From: [Juliellen Sarver](#)
To: [Onufer, Kathleen M. - PDR](#)
Subject: Main Street Improvements comments
Date: Wednesday, May 04, 2016 11:45:58 AM

East Main Street Bike Lanes

From: [John Bolecek](#)
To: [Onufer, Kathleen M. - PDR](#)
Subject: Comments on Main St / Dock St for UDC
Date: Wednesday, May 04, 2016 5:55:45 PM

Re: UDC 2016-18, Conceptual Review of East Riverfront Transportation Improvements, including Dock/Main Street Relocation

Proposed Bike Lanes

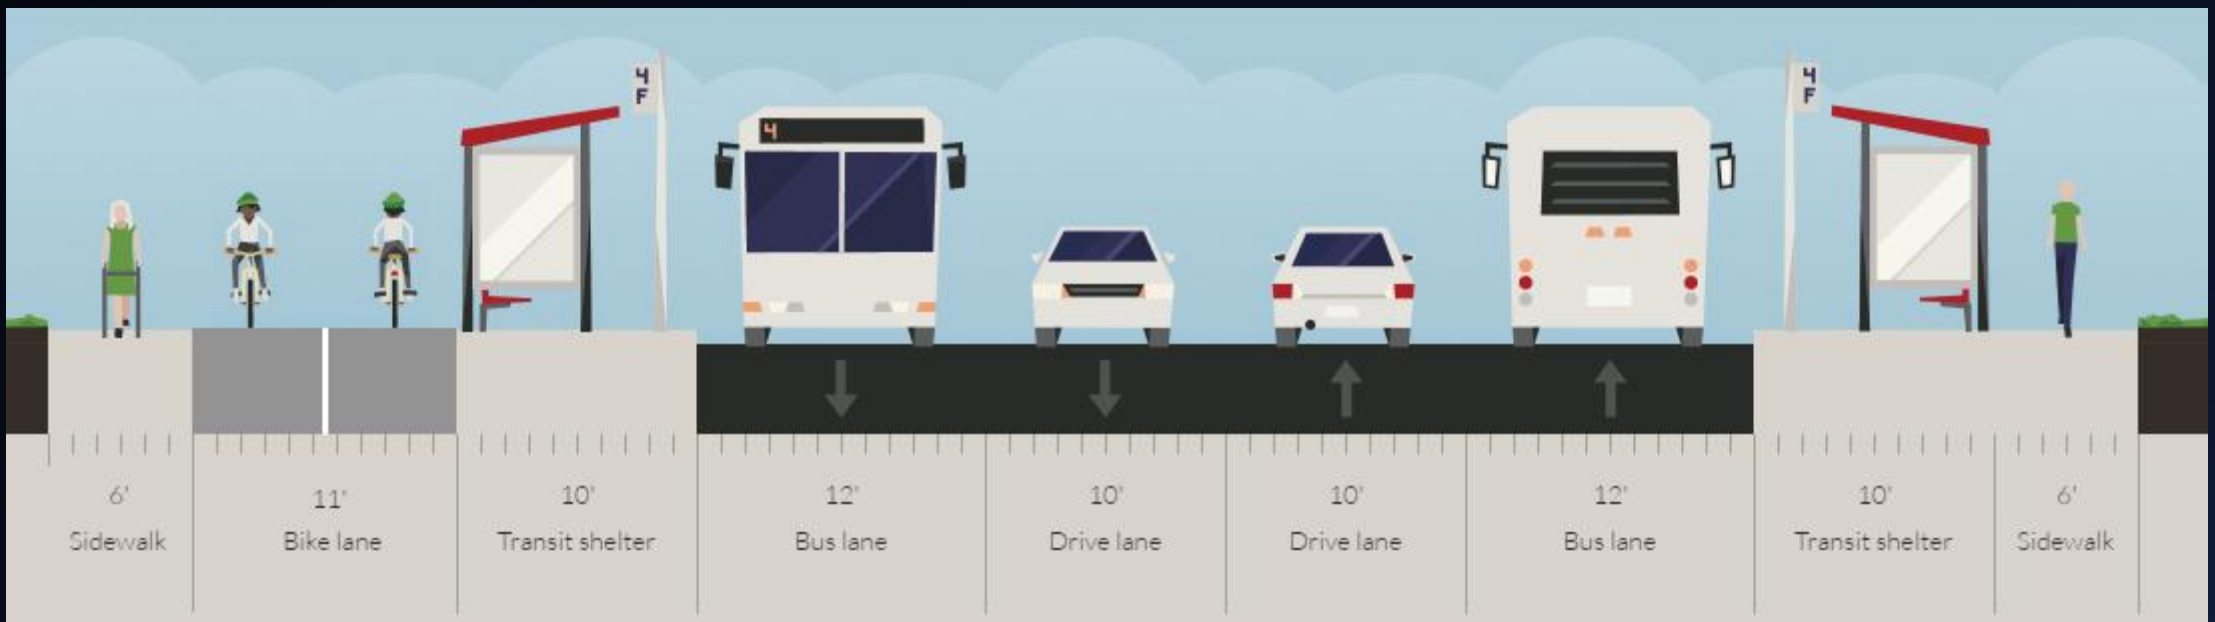
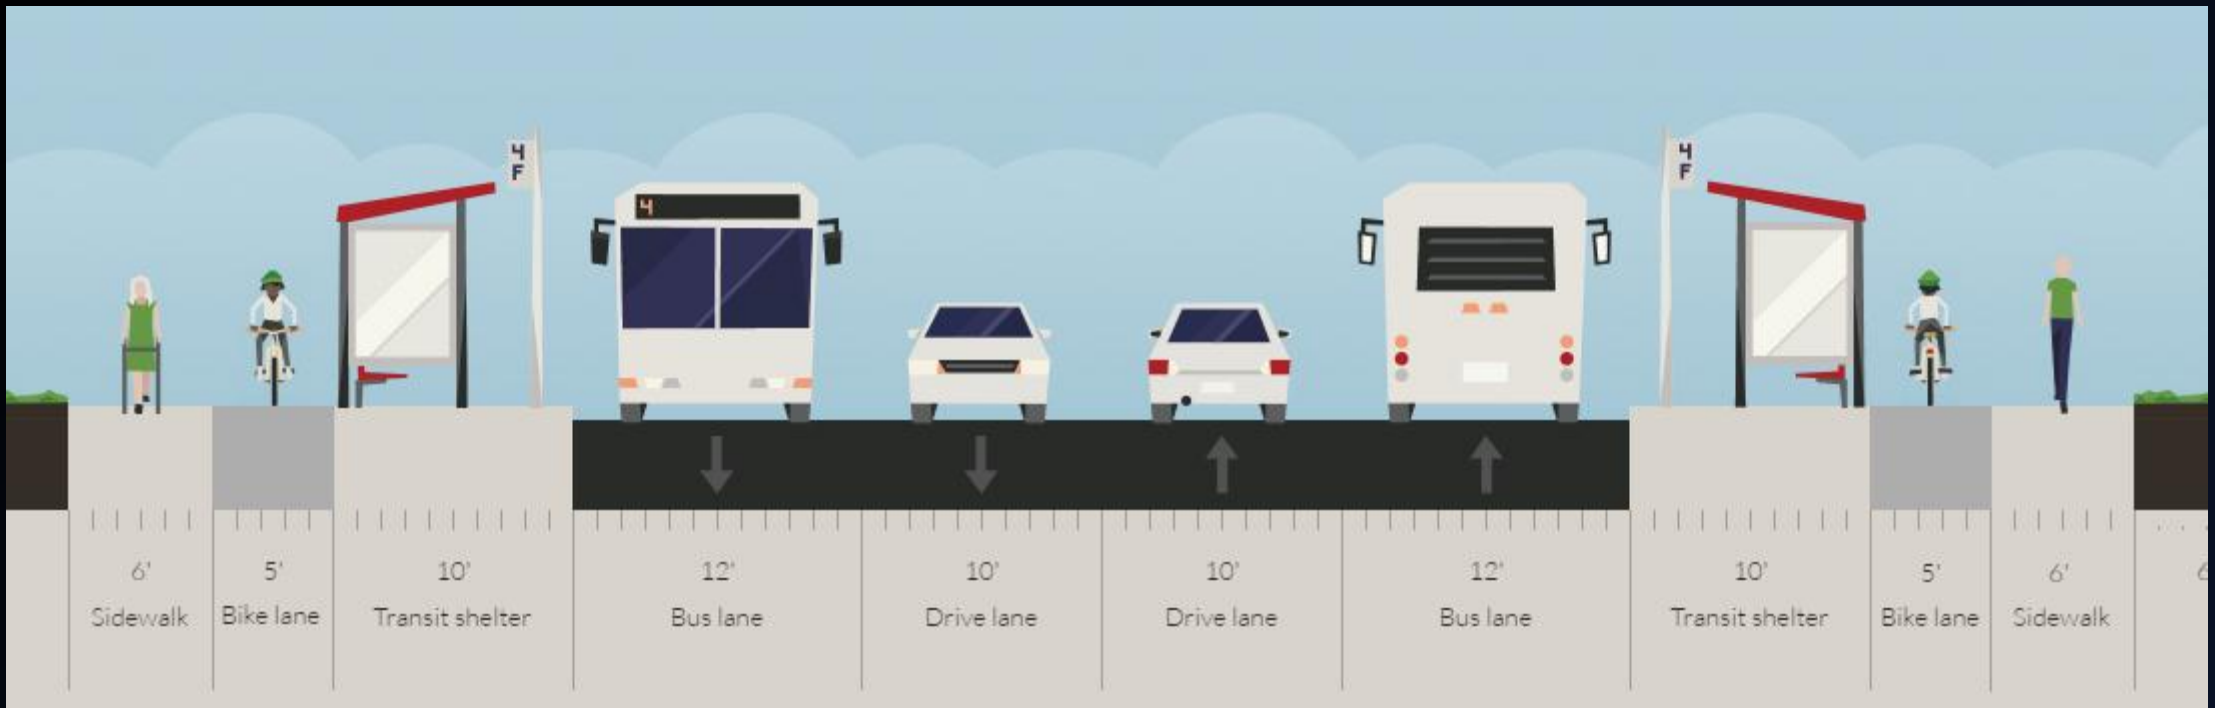
- What is currently proposed:

The Disadvantages:

- Lack of Safety
- Lack of Future flexibility
- High conflicts (buses, roundabout, etc.)

Alternative:

Curb Extensions:

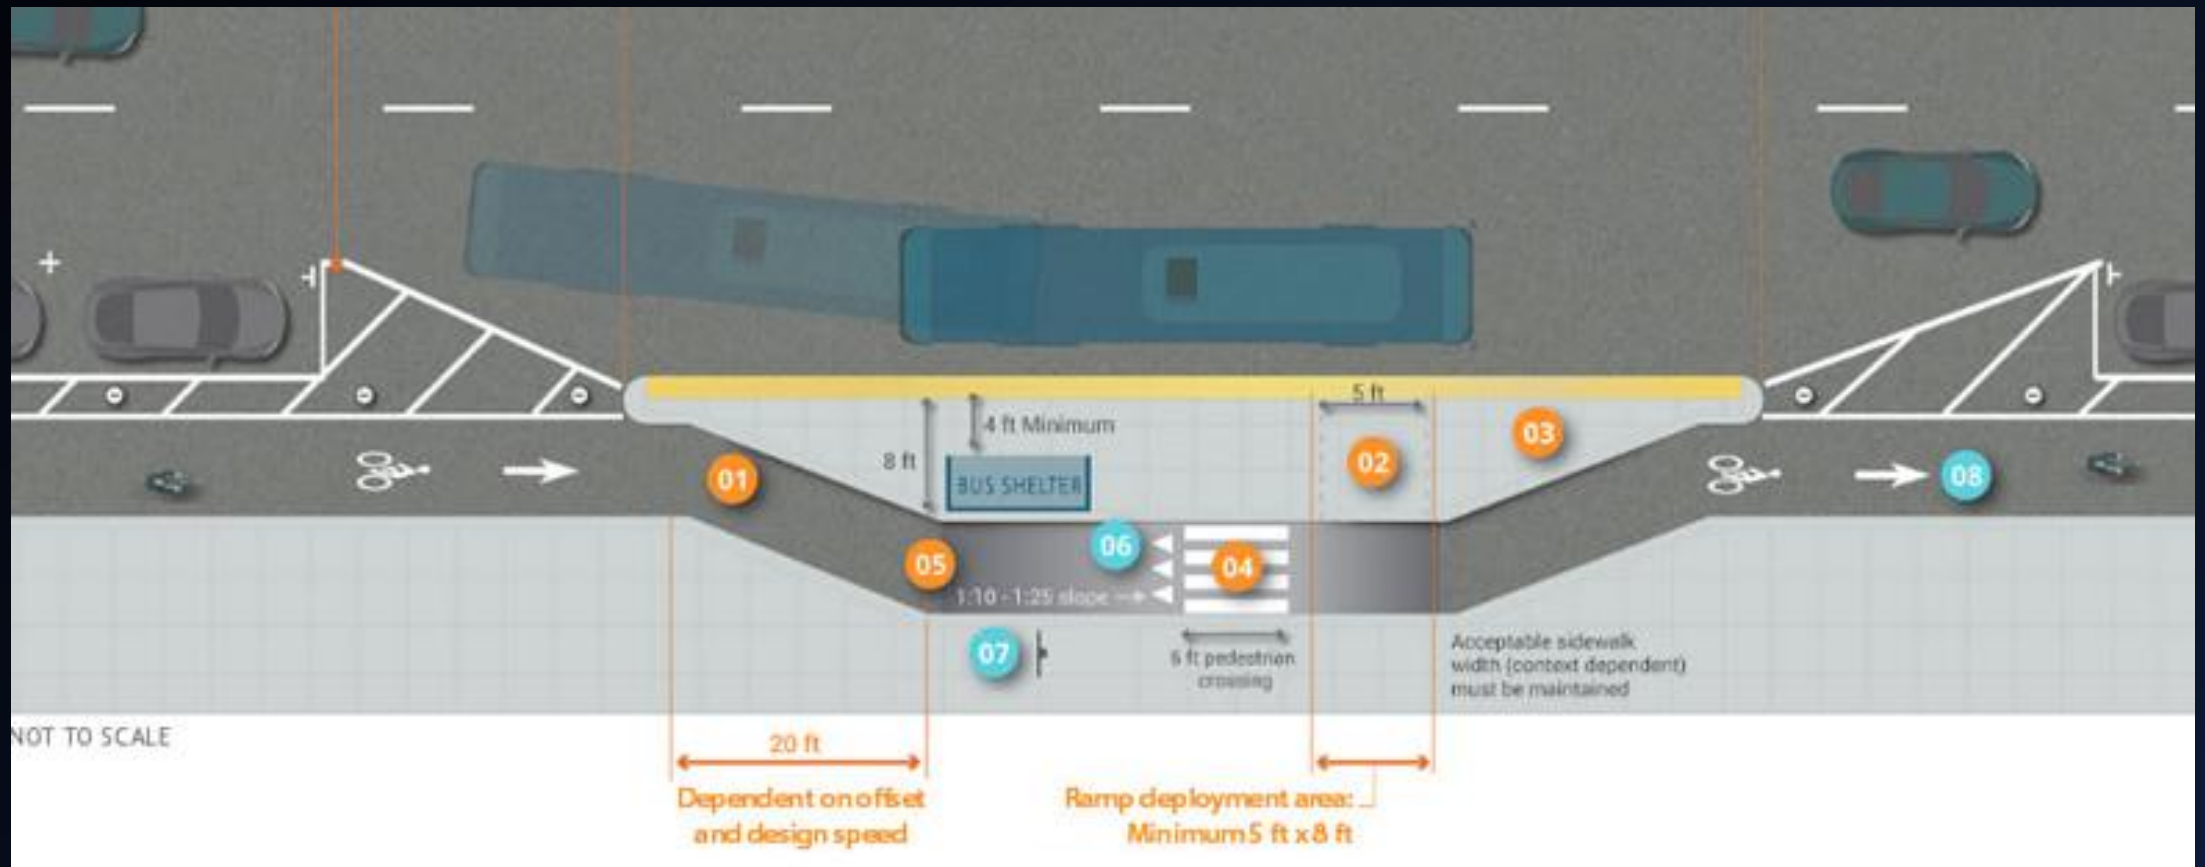
- 1. Improved Safety for all
- 2. Reduced conflicts (buses, parking, Peebles St, etc.)
- 3. Wider (shared) sidewalks on northern side = bike lanes closest to likely retail development (people on bikes spend more)
- 4. Narrower streets shorten crossing distances for pedestrians
 - Especially with curb extensions
